CITY OF ALBUQUERQUE

**Re: The Falls Restaurant Grading and Drainage Plan
Engineer's Stamp dated 5-18-06 (A13/D10B)**

GRADING PLAN

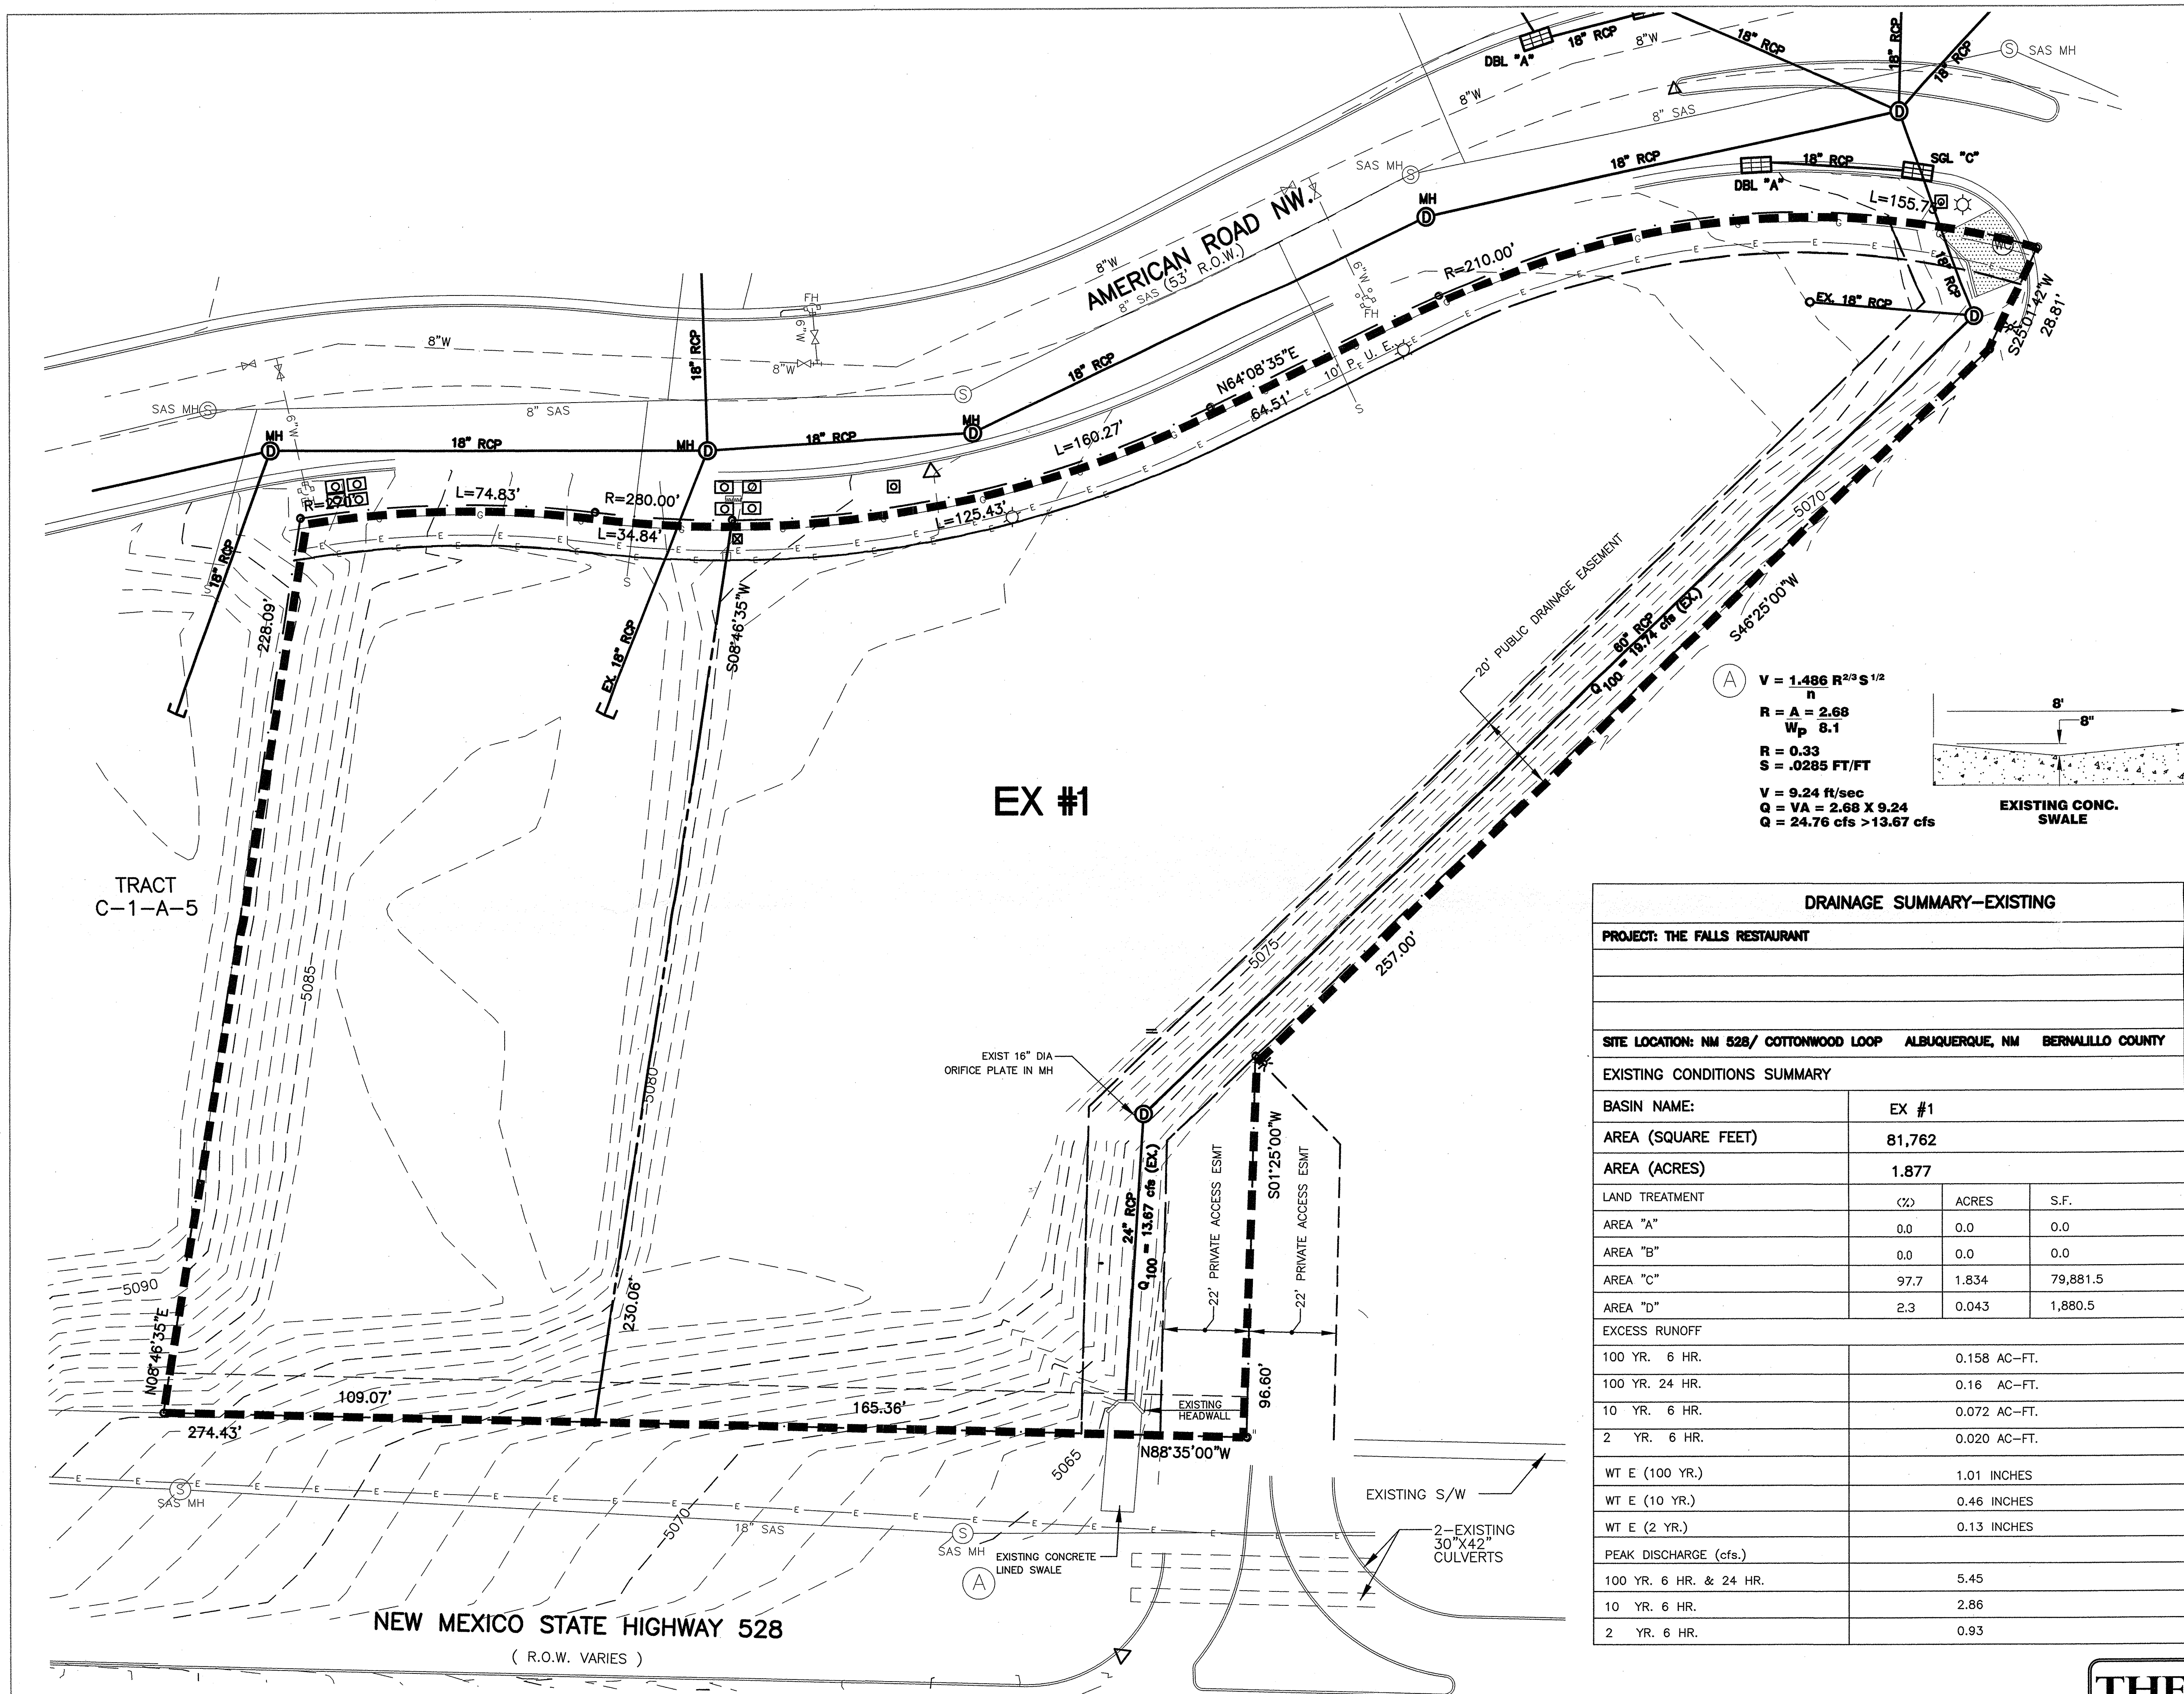
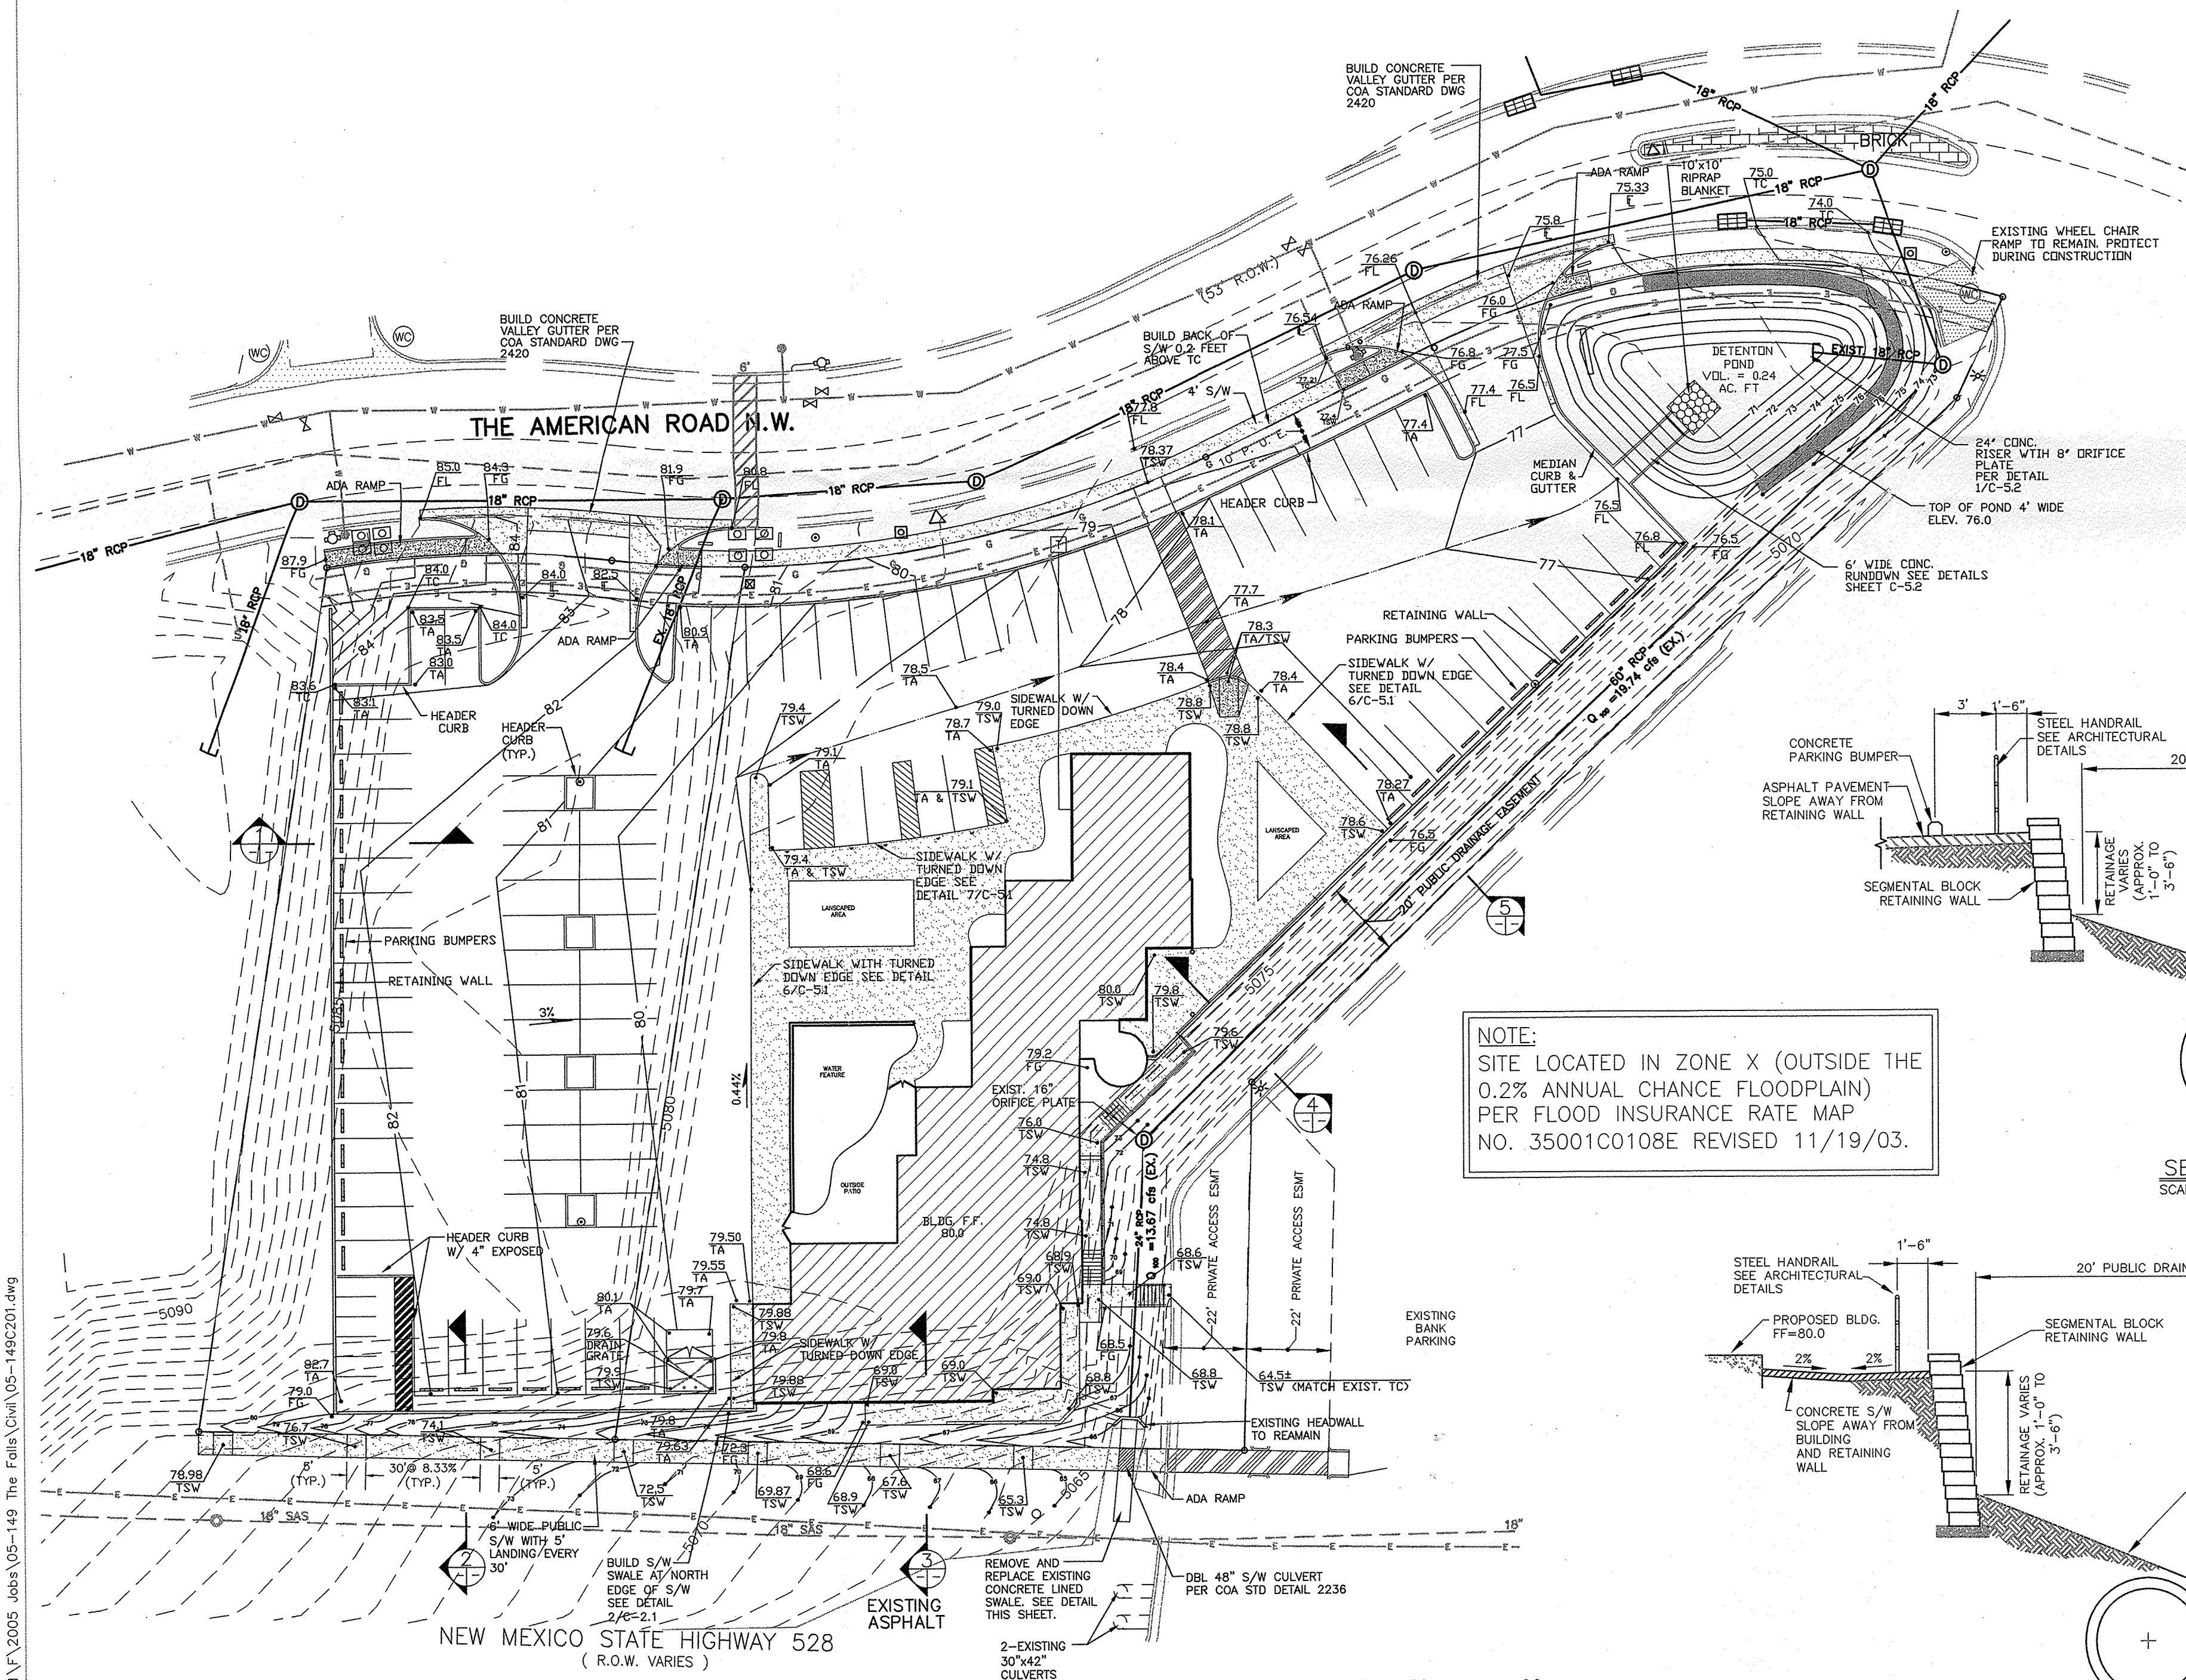
Based upon the information provided in your submittal dated 5-18-06, the above referenced plan is approved for Foundation Permit, Building Permit and Grading Permit. Please attach a copy of this approved plan to the construction sets prior to sign-off by Hydrology.
